County of Santa Cruz

July 14, 2025

Subject: Public hearing to consider appeal of Planning Department's denial of Coastal Development Permit Application, # 241334, a proposal to construct a single-family dwelling, carport and attached ADU at 625 Beach Drive

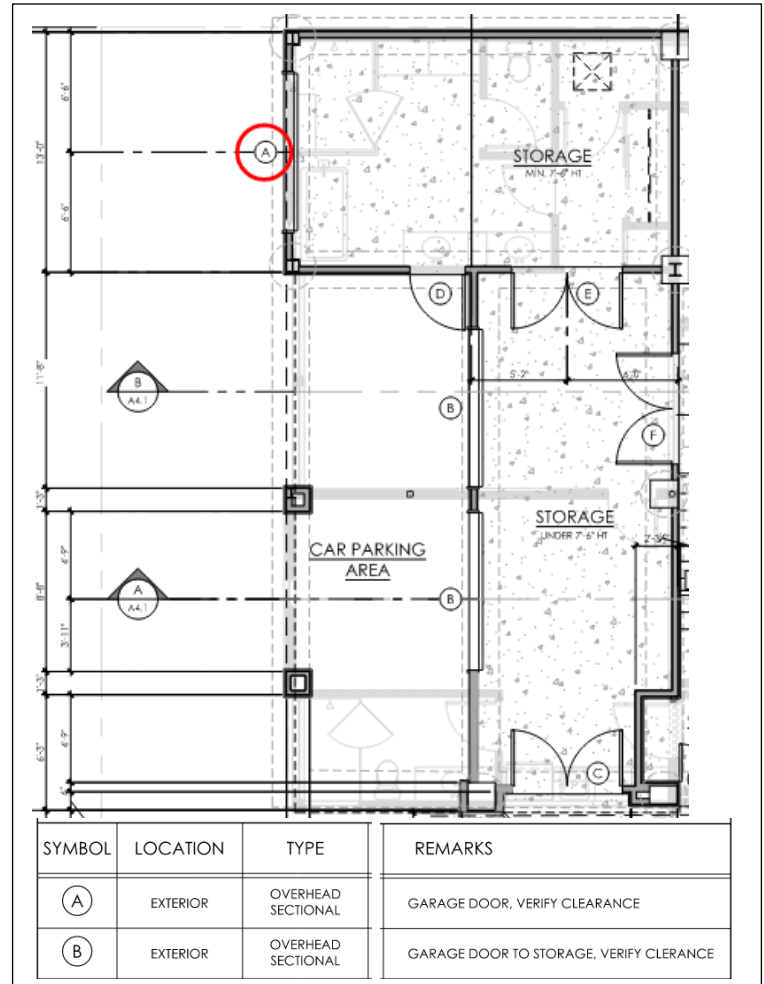
Because bluff and beach areas are excluded from the calculation of lot area for density purposes, the parcel has effectively no developable area that can be counted toward supporting two primary dwelling units. As such, the site does not meet the minimum area required to allow for two units under the applicable zoning regulations. The residential density limitation is not subject to a variance, even if one could otherwise be considered, because density is not classified as a site or structural standard; but governs intensity of use. The project's non-conformance with permitted density directly conflicts with the required findings for consistency with the Coastal Act and the County's Local Coastal Program. Accordingly, the Coastal Development Permit must be denied.

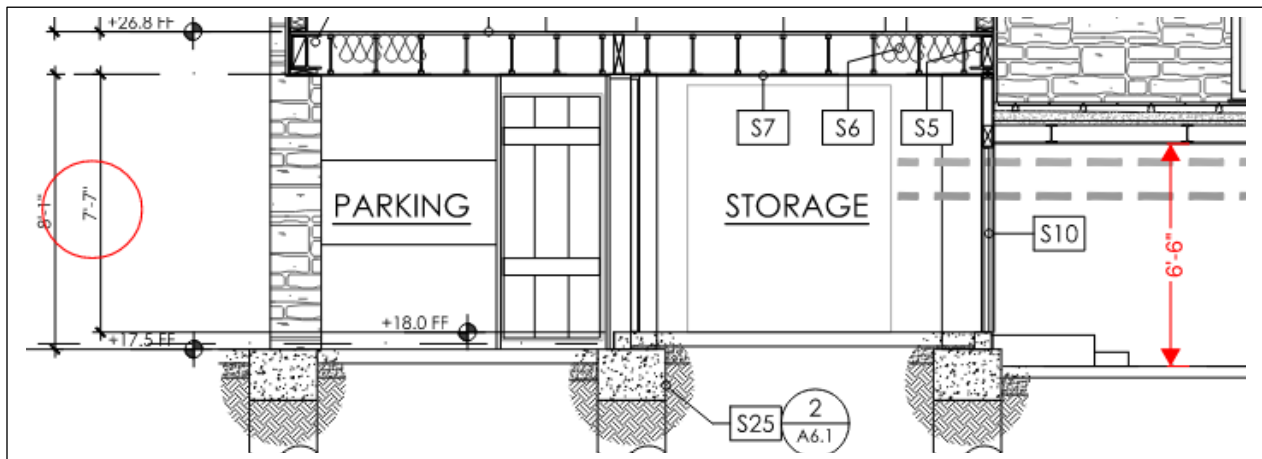
Staff Response: The enclosed area accessed by garage door “A” (circled at right) was labelled as a garage in the initial plans but relabeled as storage in the second routing. The County Code defines a garage as follows:

The space is clearly “designed for the storage of motor vehicles.” At 21 feet long by 13 feet wide, the space is large enough to accommodate a full-size parking space. Moreover, as with the parking areas under the ADU, the proposed concrete floor is reinforced to withstand the weight of a motor vehicle. Therefore, despite the revised label, this area is a garage. The garage fails to comply with the minimum 20’ garage setback in the RB zone district (SCCC [Table 13.10.323-1](#)), and therefore cannot be approved.

Staff Response: The County Code allows underfloor areas to be used for storage but does not provide for their use as garages. The section of the structure with a bedroom above and garage/storage below has two stories and is therefore noncompliant with the standards for the RB zone district, which limit structures to one story on the seaward side of Beach Drive. (SCCC [Table 13.10.323-1](#)).

An enclosed area with driveway access, garage door, a floor area and ceiling height meeting parking standards, and concrete flooring with the structural strength to support motor vehicles, is a garage and story, not an underfloor area as defined by 13.10.700-U:

It should also be noted that the proposed ceiling height within these garage and carport/storage areas has been increased to allow for an additional over 1-foot of headroom. Without this increase, which is not required to meet flood elevation standards, there would be insufficient clearance to accommodate a vehicle.

100-Year Floodplain. Parcel boundary in pale blue-green, portion outside flood plain purple.

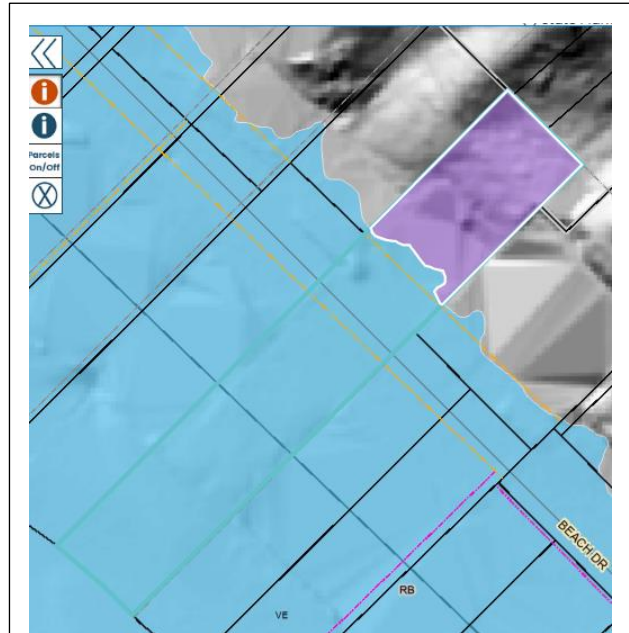
As confirmed by the project geologic report, the subject parcel is located primarily within a 100-year floodplain (FEMA VE Insurance Zone), with approximately 4,740 square feet lying outside the floodplain. The RB zone district requires a minimum of 4,000 square feet of site area per primary dwelling unit, meaning at least 8,000 square feet land located outside the floodplain is necessary to support two dwellings. As the parcel does not meet this threshold, staff cannot support a finding of consistency with County General Plan / Local Coastal Program Policy 6.2.18.1. Therefore, the proposed application cannot be approved.
